AEOD TECHNICAL REVIEW REPORT*

UNITS: Maine Yankee
Haddam Neck
DOCKET NOS: 50-309 and 50-213
LICENSEES: Maine Yankee Atomic Power
Northeast Utilities
NSSS/AE: Combustion Engineering/Stone & Webster
Westinghouse/Stone & Webster

TR REPORT NO: AEOD/T602
DATE: April 29, 1986
EVALUATOR/CONTACT: E. Leeds

SUBJECT: EMERGENCY DIESEL GENERATOR COOLING WATER SYSTEM DESIGN
DEFICIENCIES AT MAINE YANKEE AND HADDAM NECK

Figure 1 Cooling Water Control Schematic for "A" EDG at Maine Yankee

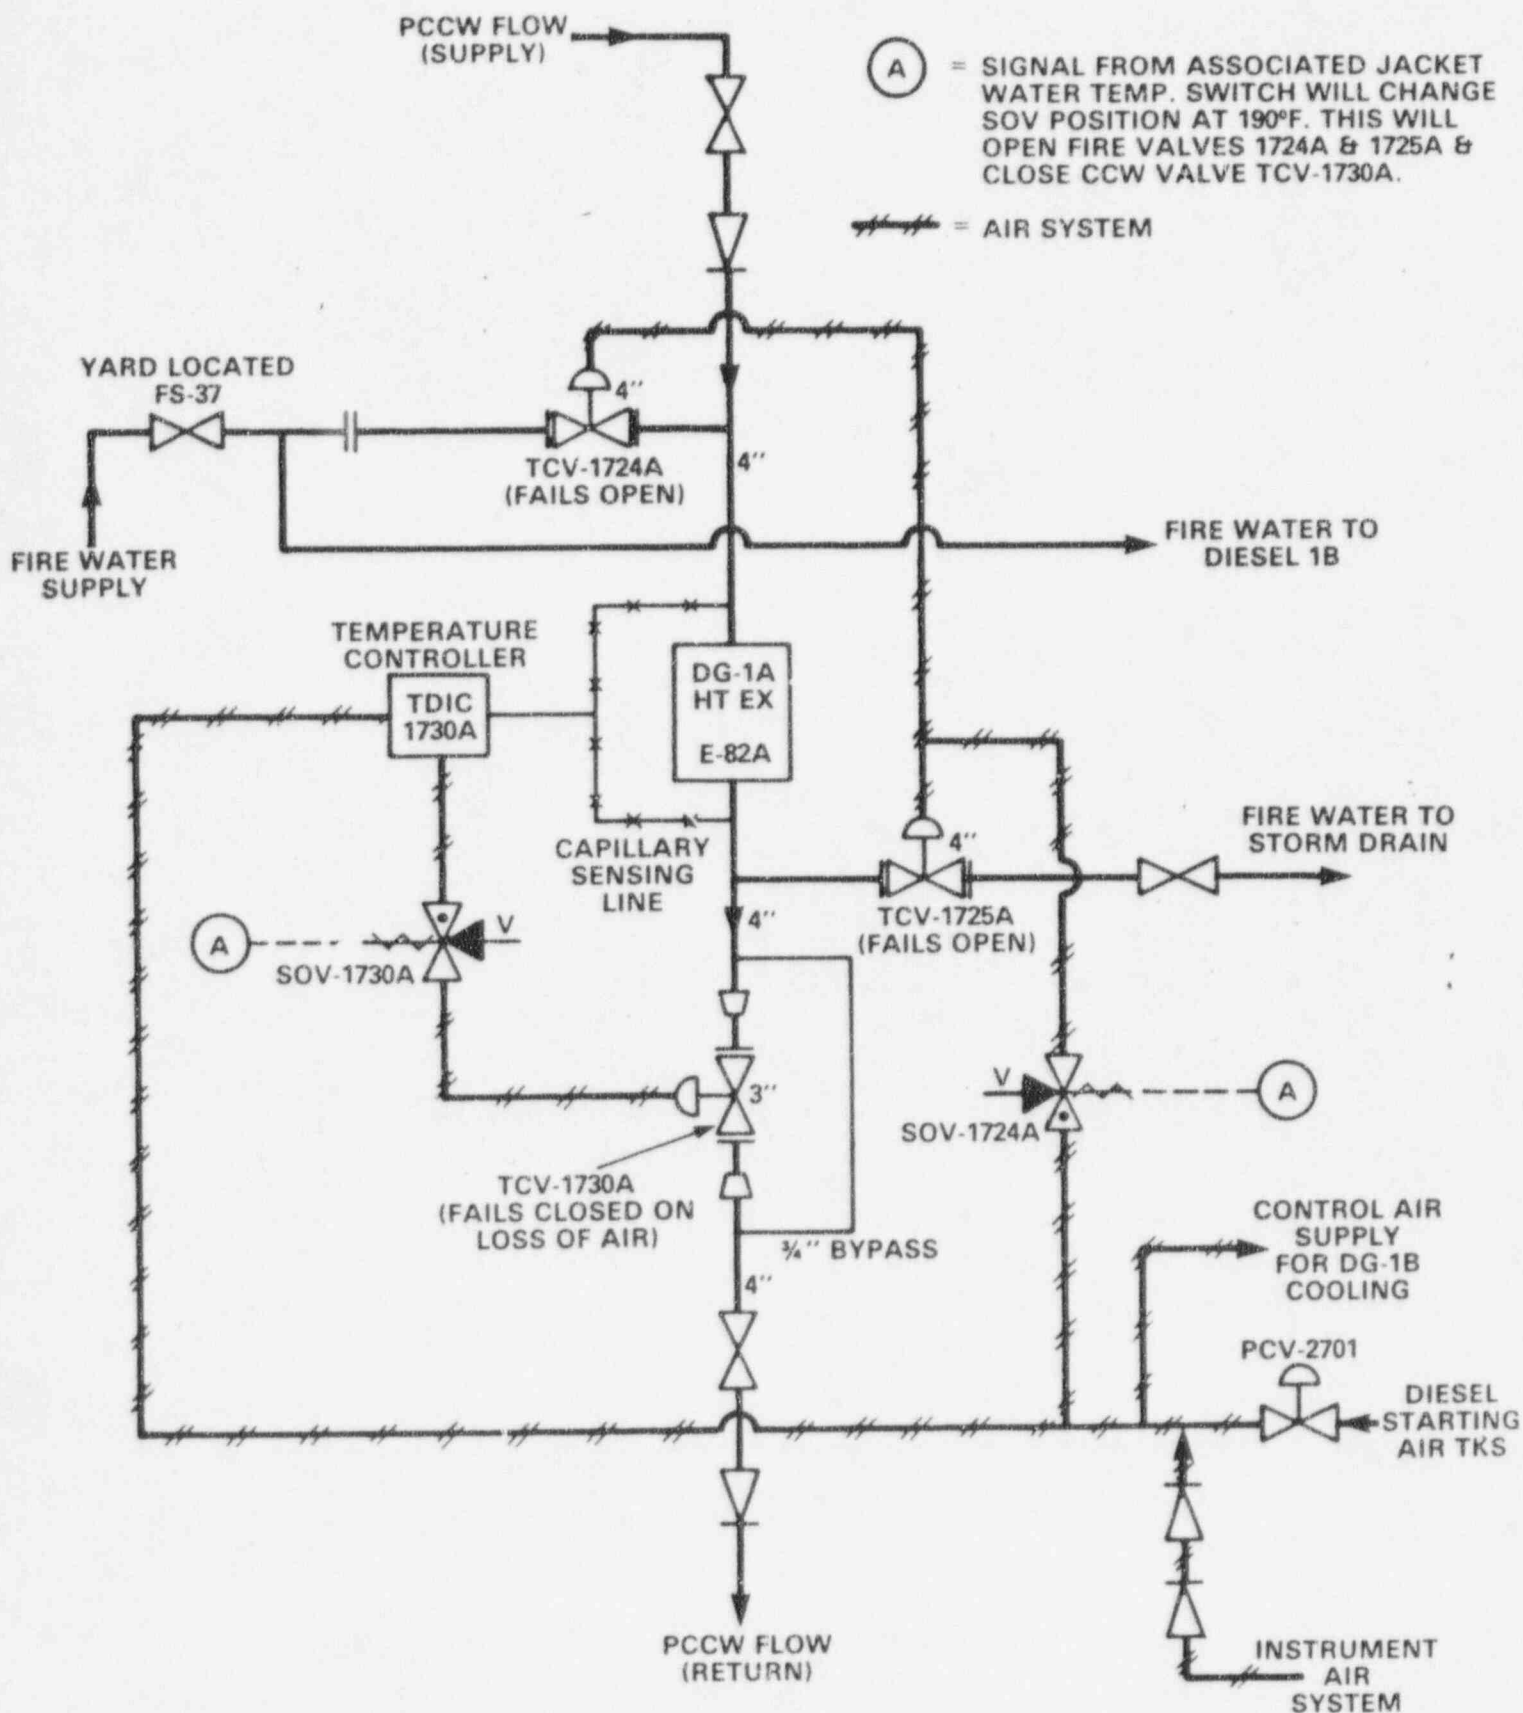
During a review of the systems required for safe shutdown and accident mitigation, personnel at the Yankee Atomic Electric Company found that the single failure of the back-up air supply regulating valve (PCV-2701) coincident with a loss of offsite power could result in the loss of cooling water to both EDG heat exchangers. Following a loss of offsite power, the instrument air system compressors would lose power, resulting in a loss of the normal (instrument) air supply to the temperature control valves. A failure of the backup air supply regulating valve would then result in a complete loss of air to the temperature control valves. With a loss of air pressure the temperature control valves would fail closed and the fire water control valves would fail open to allow backup fire water cooling to the heat exchangers. However, because the fire water cooling supply system had been isolated, a loss of the normal and backup air supplies to the temperature control valves would result in a complete loss of cooling water to both EDG heat exchangers.

The licensee's corrective action consisted of blocking open the temperature control valves to provide continuous full cooling flow to both EDG heat exchangers. The temperature control valves were originally designed to be positioned by a temperature controller to maintain a 25°F delta-temperature across each EDG heat exchanger (see Figure 1). This arrangement was used to balance the component cooling water flow demand. However, the licensee determined that full cooling flow through the heat exchangers was acceptable in regard to the cooling loads of the PCCW and SCCW systems. Additionally, full cooling flow to the heat exchangers did not impact on the EDG lube oil and jacket water temperatures because each EDG has an internal "thermostat" to specifically regulate the lube oil and jacket water temperatures. Finally, the licensee determined that full cooling flow would not adversely increase the rate of heat exchanger tube erosion. Therefore, blocking the temperature control valves open was acceptable and would eliminate the possibility of a loss of air supply causing a loss of cooling water to both EDG heat exchangers.

Figure 2 Emergency Electric Distribution for MCC-5 at Haddam Neck

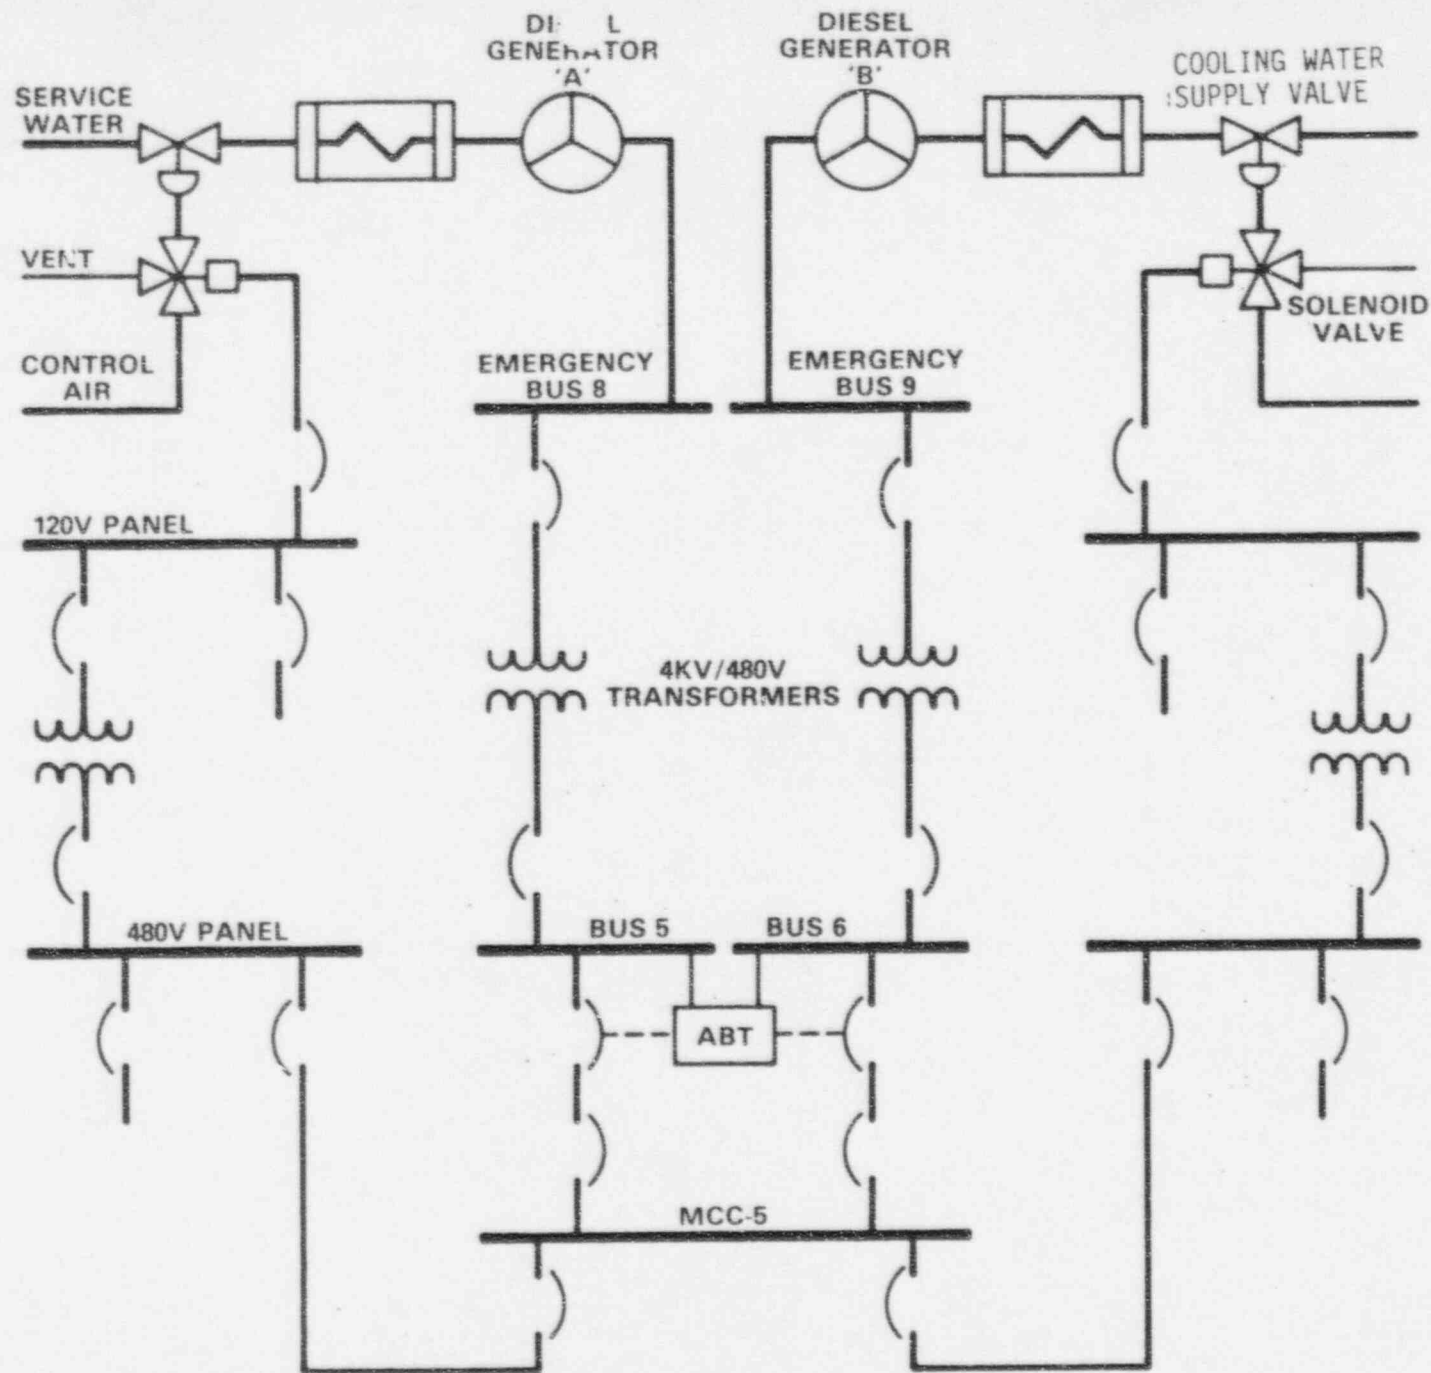
The solenoid air pilot valves for both EDGs are supplied electrical power from MCC-5. This MCC normally is supplied by offsite power though emergency Buses 8 and 9. The MCC is supplied with emergency ac power from either EDG via an ABT (Figure 2) in the event that offsite power is unavailable. The scenario identified by the licensee, which could lead to a loss of cooling water to both EDGs, involves a postulated loss of offsite power and the coincident failure of the ABT for MCC-5. The ABT failure sequence is as follows: Initially, offsite power is assumed to be supplying Buses 5 and 6 and the preferred source selector switch for the ABT is assumed to be set for Bus 5. In this alignment, Bus 5 is supplying power to MCC-5 (the Bus 5 output breaker is shut). The scenario begins with a loss of offsite power which results in a loss of power to emergency Buses 8 and 9 and consequently to Buses 5 and 6. As soon as the electrical frequency associated with Bus 5 decreases by a predetermined amount, the ABT, as designed, would open the Bus 5 output breaker. However, since the electrical frequency associated with Bus 6 would also decrease by the same amount, the ABT will not shut the bus 6 output breaker. Thus, MCC-5 would be deenergized with both Bus 5 and Bus 6 output breakers open. However, the EDGs start following a loss of offsite power and begin to load 10 to 13 seconds later. When the EDGs reenergize Buses 5 and 6, the ABT would sense that the selected source (Bus 5) had electrical power and would attempt to shut the Bus 5 output breaker. It is postulated that the Bus 5 output breaker fails to close (single failure). By design, the ABT would continue to attempt to shut the selected source (Bus 5) output breaker as long as the bus had electrical power. The ABT will not transfer and shut the alternate source (Bus 6) output breaker unless electrical power to Bus 5 is interrupted or an operator selects bus 6 with the ABT's preferred source selector switch. Thus, MCC-5 would be deenergized with neither Bus 5 nor Bus 6 supplying power. In this situation, the EDG cooling water supply valves would remain closed since the solenoid valves would have no power to reposition to vent air from the cooling water supply valve air actuators.

The licensee blocked the EDG cooling water supply valves open by removing the control air lines which provide the air pressure necessary to hold the valves closed. This eliminates the potential for a loss of electrical power to MCC-5 to cause a loss of cooling water to the EDG heat exchangers. However, redundant and nonredundant equipment necessary for safety injection is still powered from MCC-5. A coincident loss of MCC-5 during a postulated loss of coolant accident (LOCA) would prevent initiation of safety injection and could lead to core damage. The resident inspector at Haddam Neck has raised this concern with the licensee (Ref. 6). The licensee stated that the probability of a LOCA with a loss of offsite power and coincident loss of MCC-5 is sufficiently low that immediate corrective action is not required. Region 1 has requested the Office of Nuclear Reactor Regulation (NRR) to review the potential concerns resulting from the new higher probability scenario for a loss of MCC-5 (Ref. 7). The region has also requested NRR to take the lead responsibility for reviewing the recently completed probabilistic safety study and for determining whether the
